Project	IEEE 802.16 Broadband Wireless Access Working Group < http://ieee802.org/16 >	
Title	Enhancements to UCP LBT	
Date Submitted	2007-09-07	
Source(s)	Paul Piggin NextWave Broadband Ken Stanwood NextWave Wireless Yair Bourlas NextWave Broadband Kathy Sohrabi NextWave Broadband	Voice: + 44 1249 800167 E-mail: ppiggin@nextwave.com Voice: +1 858 480 3327 E-mail: kstanwood@cygnuscom.com Voice: +1 858 480 3279 E-mail: ybourlas@nextwave.com Voice: +1 858 480 0549 E-mail: ksohrabi@nextwave.com
Re:	IEEE 80216-07/019 Task Group Review of P802.16h/D2c	
Abstract	Enhancement to UCP LBT based on simulation results and analysis	
Purpose	To address a handful of improvements to the LBT portion of the section 6.4 UCP.	
Notice	<i>This document does not represent the agreed views of the IEEE 802.16 Working Group or any of its subgroups. It represents only the views of the participants listed in the "Source(s)" field above. It is offered as a basis for discussion. It is not binding on the contributor(s), who reserve(s) the right to add, amend or withdraw material contained herein.</i>

Enhancements to UCP LBT

This document provides changes to IEEE P802.16h/D2b [1].

Figure h1—Basic LBT Opportunities

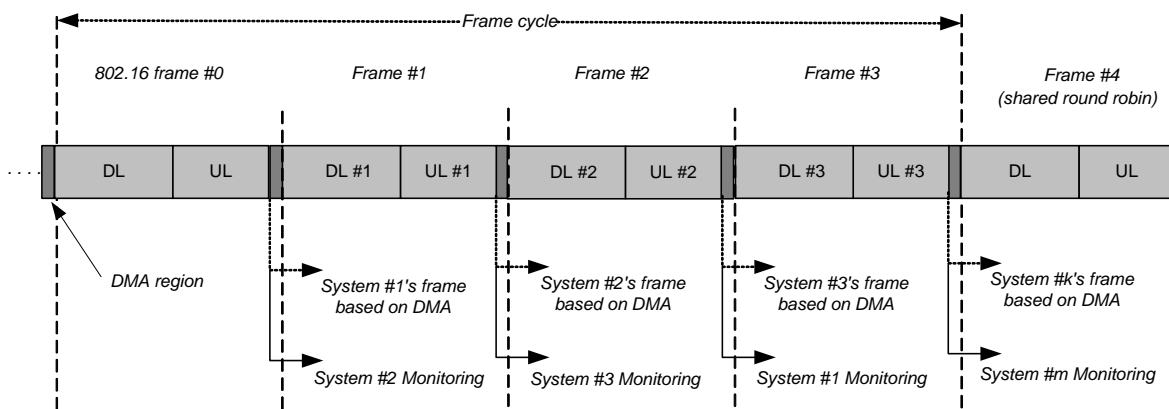
In ~~a similar way in~~ the gap between the UL and DL subframes, ~~as close to time to transmit the DL as possible,~~ the BS shall make measurements on the current state of the channel. The general case with three co-channel 802.16 systems is shown in *Figure h 1*.

The gap between the end of the UL and the start of the DL in which the CMA is performed must be of sufficient length to allow an asynchronous system to claim the channel if necessary. For instance if the asynchronous system is an 802.11 system, the gap must be at least the duration of the 802.11 AIFS in the band of interest.

Figure h2—LBT - UL MAP Relevance N

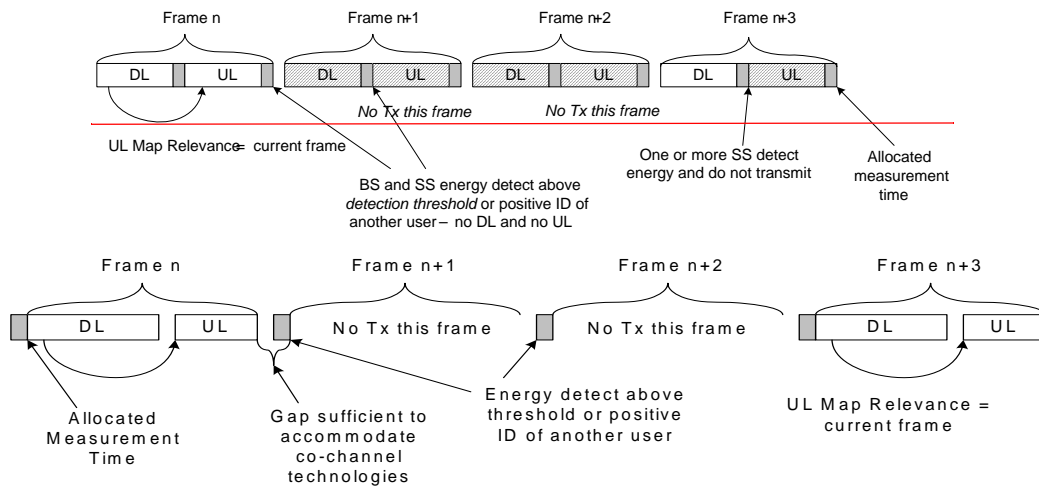
When attempting to coexist with certain [asynchronous](#) non-802.16 users of non-exclusively assigned or non-exclusively licensed bands, EQPs may not be sufficient. In these cases, a LBT protocol must be used [and EQP are optional](#). In such bands, ~~the BS shall operate with a UL-MAP relevance of the current frame. This allows~~ the DL and UL subframes to be logically viewed as a single "packet" of constant duration equal to the frame duration. [Steps are taken, as described below to use this concept to minimize interference with co-channel asynchronous systems.](#) The BS shall periodically allocate opportunities for an SS to measure and report on the current state of the channel, and provide input to the LBT protocol. An Extended Channel Measurement IE (see for example sub clause 8.4.5.3.5) may be used, to provide such an opportunity.

[Replace the following Figure.]

Figure h4—Reclaiming the Medium

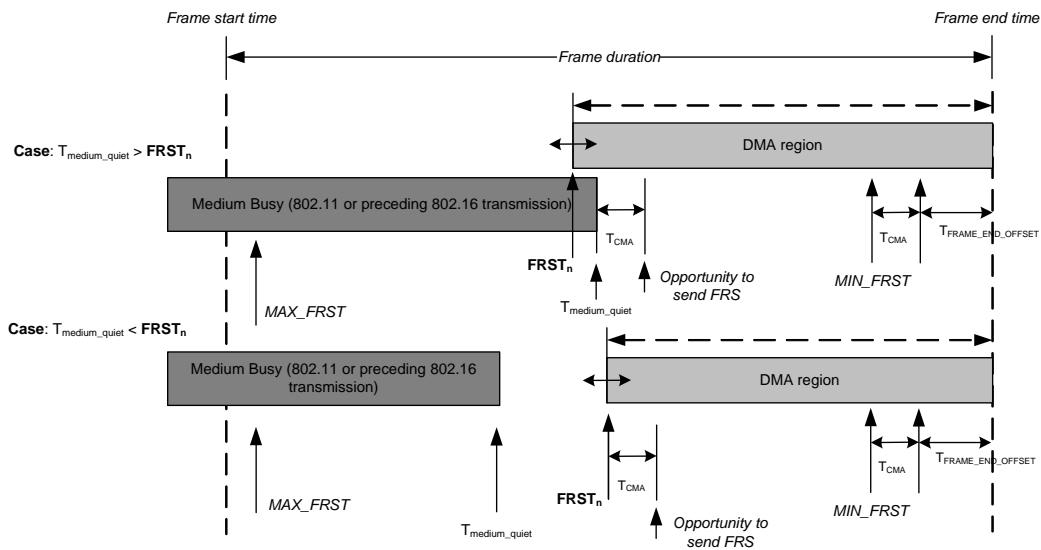
If the BS's current utilization of the channel is less than its utilization goal, the BS exerts extra effort to reclaim the medium by assessing the channel conditions increasingly earlier before the start of the DL subframe up to a point in time, *MINFRST*, described below. When the BS detects the medium is available, it transmits an FRS to claim the downlink subframe. The protocol has the following terms and equations:

The parameters are applied as shown in Figure h 4.

$MIN_FRST = T_{CMA} + T_{FRAME_END_OFFSET}$
 $T_{FRAME_END_OFFSET} = 50\mu s$ (minimum time to Rx/Tx and send FRS)
 $T_{CCA} = 4/8/16\mu s$ (20MHz/10MHz/5MHz channels) – aligned with 802.11 values
 $MIN_FRST = 54/58/66\mu s$
 $MAX_FRST = 4000\mu s$
 802.16 parameters
 5ms 802.16 frame duration
 47 symbols per frame [DL=28, UL=19] symbol duration ~102μs
 TTG = 5μs

Figure h5—BS Dynamic Medium Access Protocol

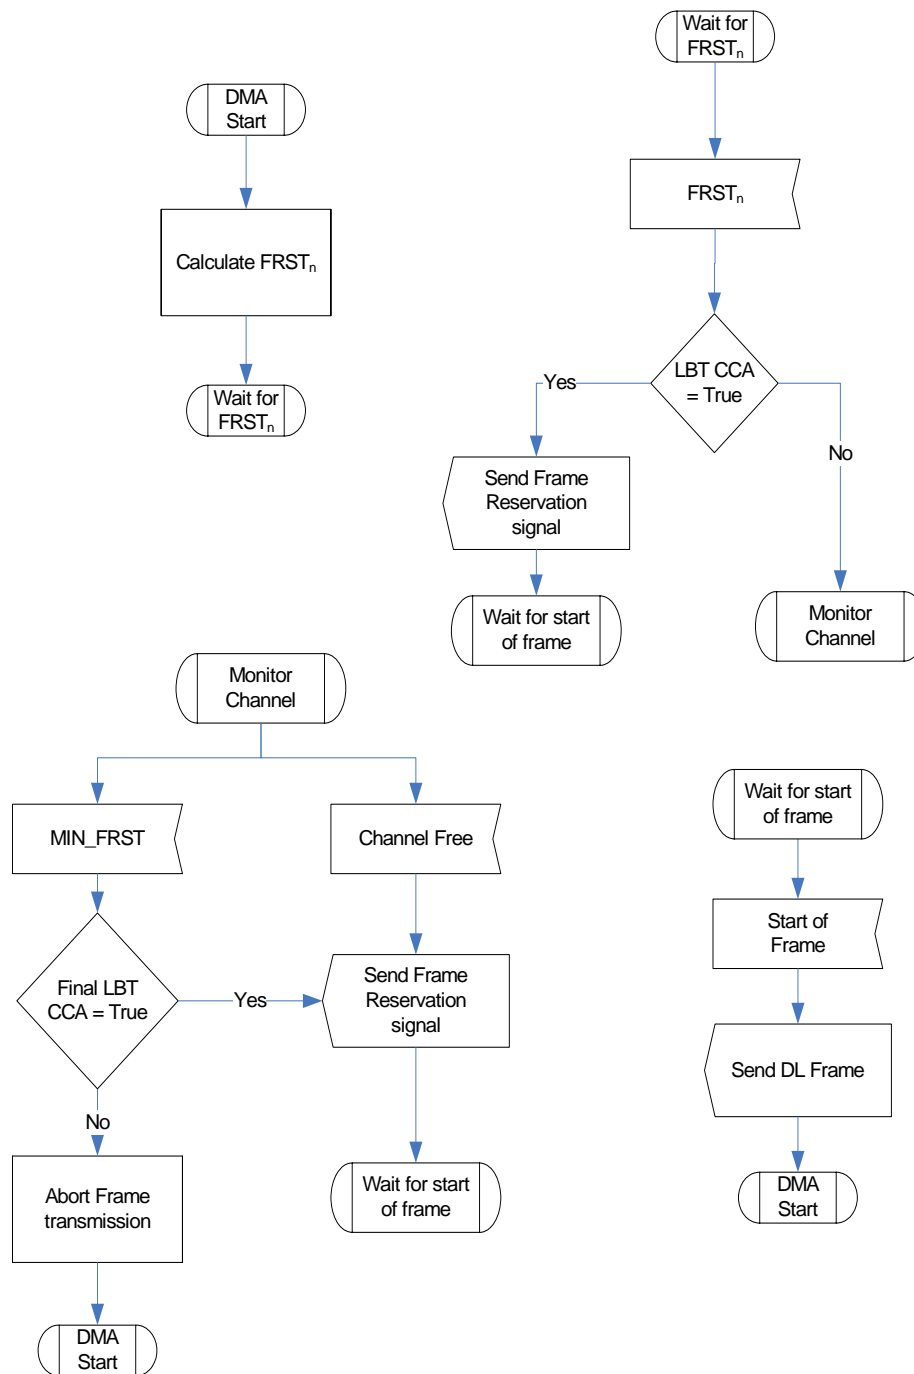
The BS SDL for the DMA protocol for reclaiming the medium is shown in Figure h 5.

Figure h6—UL FRS

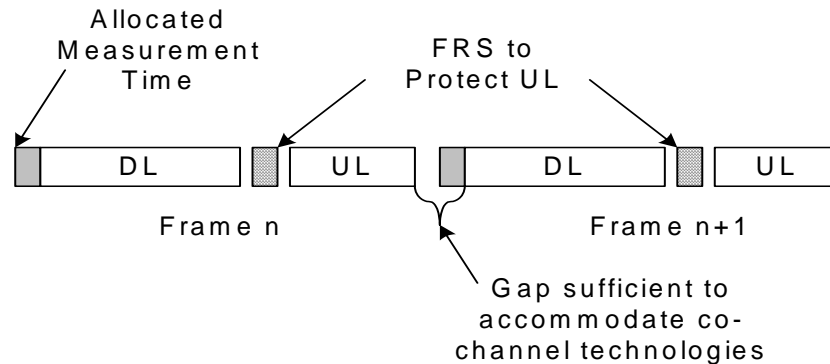
When using any carrier sense protocol, such as LBT, in a wireless environment the hidden node problem cannot be 100% avoided. It can only be mitigated. Additionally, in bands such as 3.65 GHz in the US, there is an aggravated hidden node problem due to the distinctly lower transmit power allowed for mobile devices compared to fixed, registered devices. The mobiles are more often geographically disadvantaged due to this transmit power disparity. Fixed, registered client devices can also be geographically disadvantaged (the classical hidden node problem), although not as often. To remedy this the BS transmits a Frame Reservation Signal (FRS) at the end of the DL subframe to reserve

[the subsequent UL subframe \(or used portion, thereof\) for the subscriber stations. The form of the FRS is band dependent and should be structured so as to be as receivable as possible by other technologies that may be co-channel. For instance, in bands where 802.11 would be a typical co-channel asynchronous system, the 802.11 CTS transmitted using the appropriate 802.11 burst structure would suffice. The reservation of the UL subframe by the BTS precludes the need for the SS to also perform LBT. The use of the FRS to protect the UL is shown in Figure h 6.](#)
